NO: Sw - 158	PRODUCT: B3FS-4 series – Tactile Switch
DATE: February 2026	TYPE: MODIFICATION – Lot Code Marking and Base Mold Gate change

B3FS-4 series Tactile Switch - Lot Code Marking and Base Mold Gate change

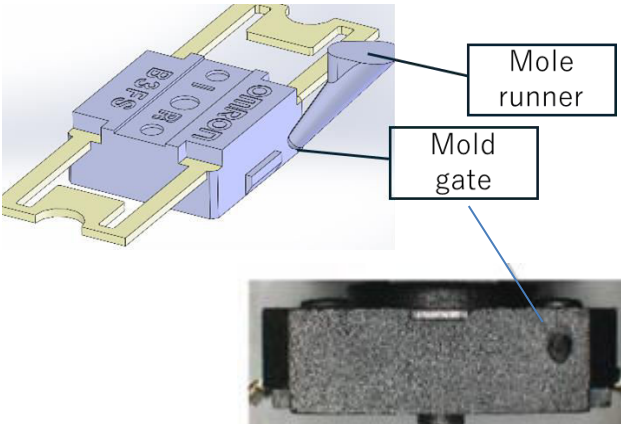
Before the change	After the change
Lot Code Marking	Lot Code Marking
<p>Position: Top side on cover</p> <p>Number of digits: Two-digit notation</p> <p>Marking method: Engraving</p>	<p>Position: On side of Base part Removed from top side on cover</p> <p>Number of digits: Seven-digit notation</p> <p>Marking method: Laser</p>

<p>Lot Code decoding:</p> <p>A : Day 01,02,03···30,31 B: Month 1,2,3,···X(10),Y(11),Z(12) C: Year (The last character of the year notation.) D: Code of Production site E: Management number F: Management number</p>

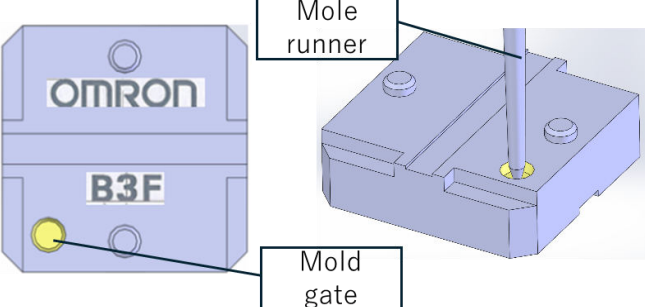
Before the change	After the change
<p>Molded gate Position: On side of base</p> 	<p>Molded gate Position: On bottom of base</p>  <p>Note: Gate position subject to change.</p>
